ADDENDUM NO. 3
February 20, 2025

PROJECT: LeRoy Craig Jerome Center
College of Southern Idaho
Jerome, Idaho

Addendum #3 – CSI LeRoy Craig Jerome Center

Date:	02/20/25	To:	LKV Architects
Job Number:	23-319		2400 E. Riverside Drive
Prepared By:	Joe Davies		Boise, ID 83706
Sheet:	1 of 1	Attention:	Greg Bush / Ron Polintan
Project:	<u>CSI – LeRoy Craig Jerome Center</u>

DRAWN BY: CJ
CHECKED BY: JB
BID SET
DRAWING NO.
SD3.0
LAYOUT PLAN

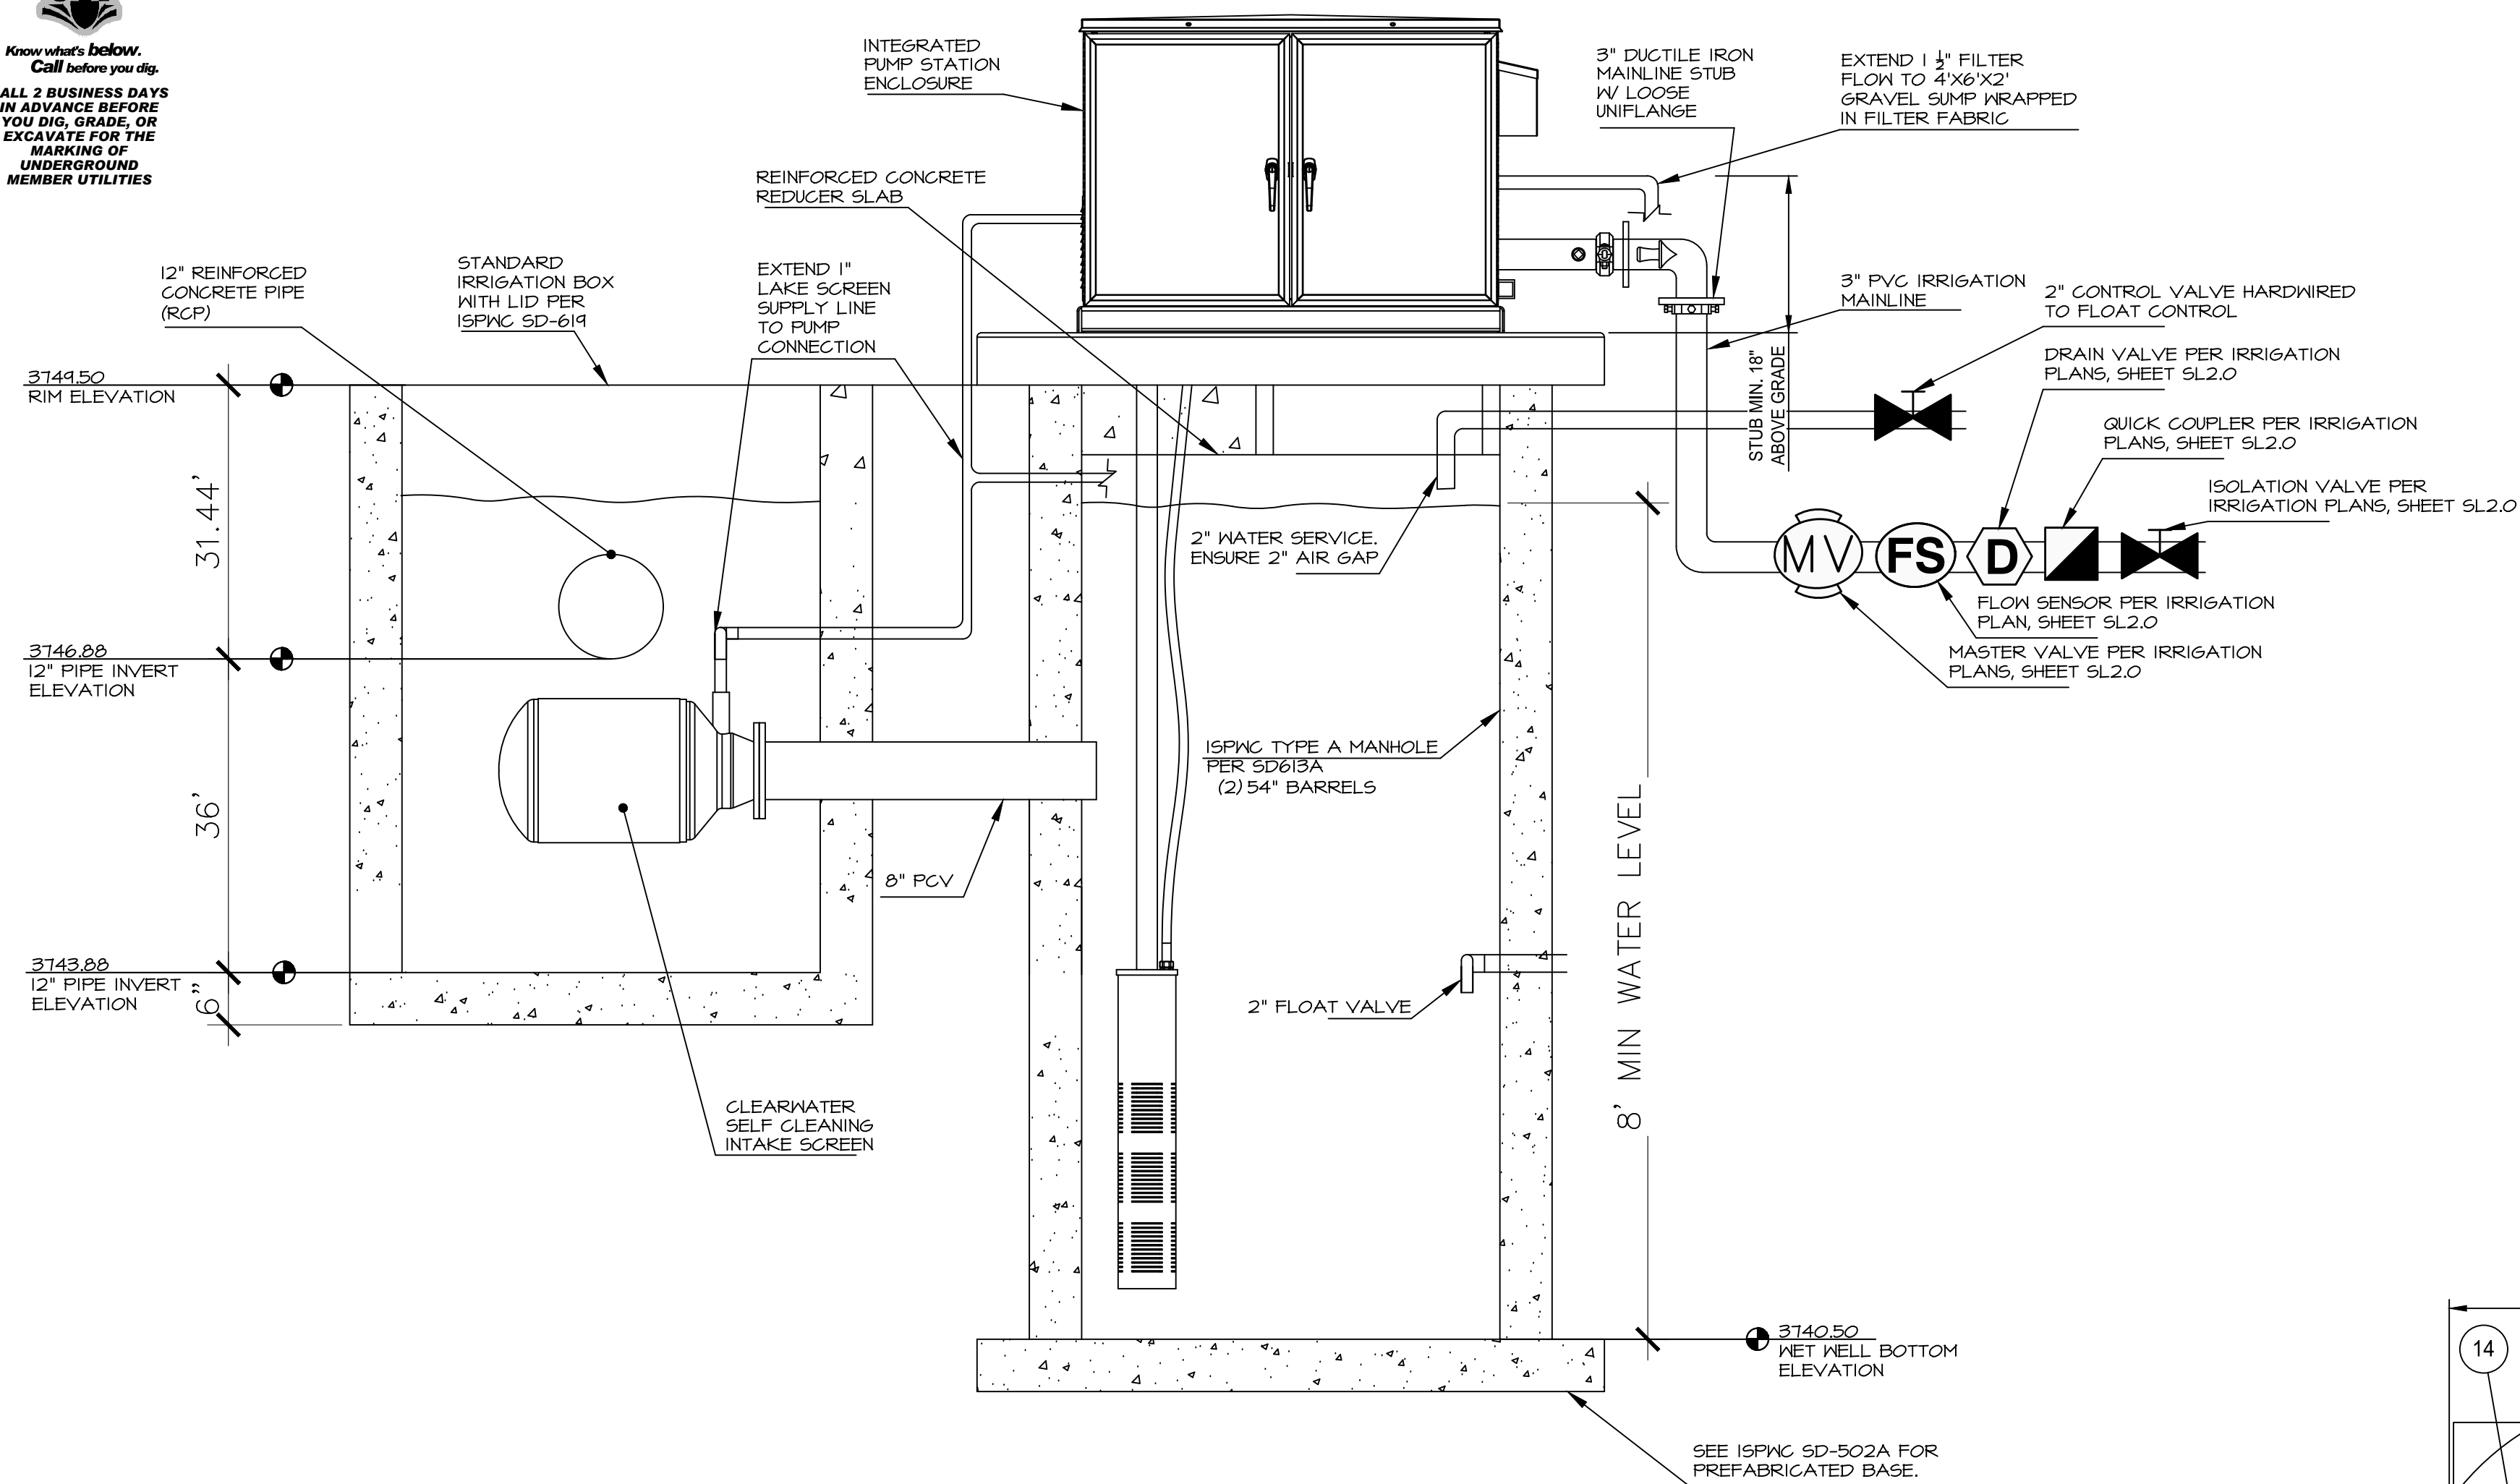
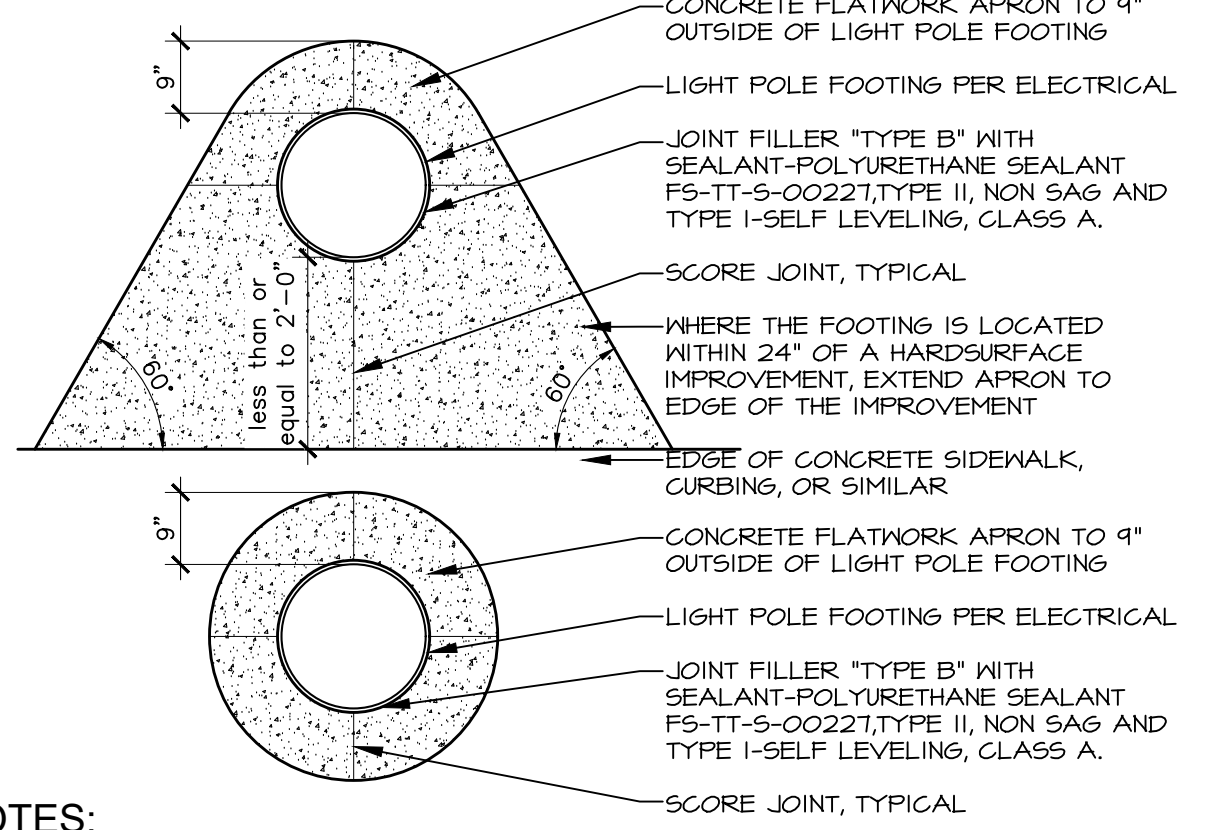
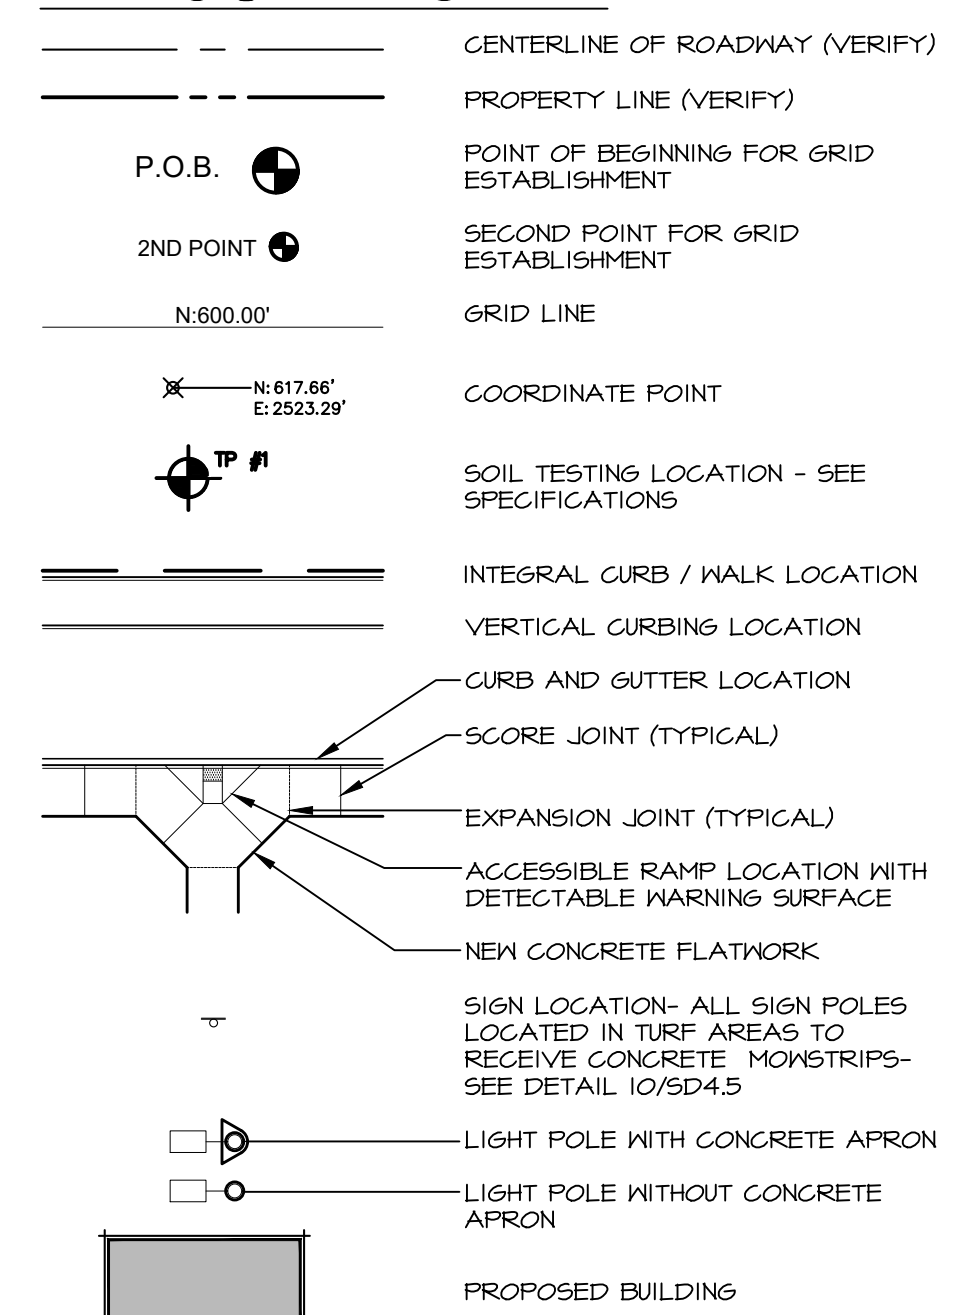
- 1-2 Sheet SD3.0, Add callout 28 for concrete apron at flagpole location.
- 1-3 Sheet SD3.0, Add detail 2 per attached sheet SD3.0A with flagpole concrete apron detail.
- 1-4 Sheet SL2.6, Revise pump station design specifications.

- BIKE RACK AS SPECIFIED (TYPICAL OF 4)
- VERTICAL CURB LOCATION, SEE DETAIL 5/SD3.5.
- STEEL BOLLARDS, SEE DETAIL 2/SD3.7
- FLAGPOLE AS SPECIFIED WITH CONCRETE APRON PER DETAIL 2/SD3.0. INSTALL PER MANUFACTURER'S RECOMMENDATIONS. COORDINATE POWER CONNECTION WITH ELECTRICAL PLANS.
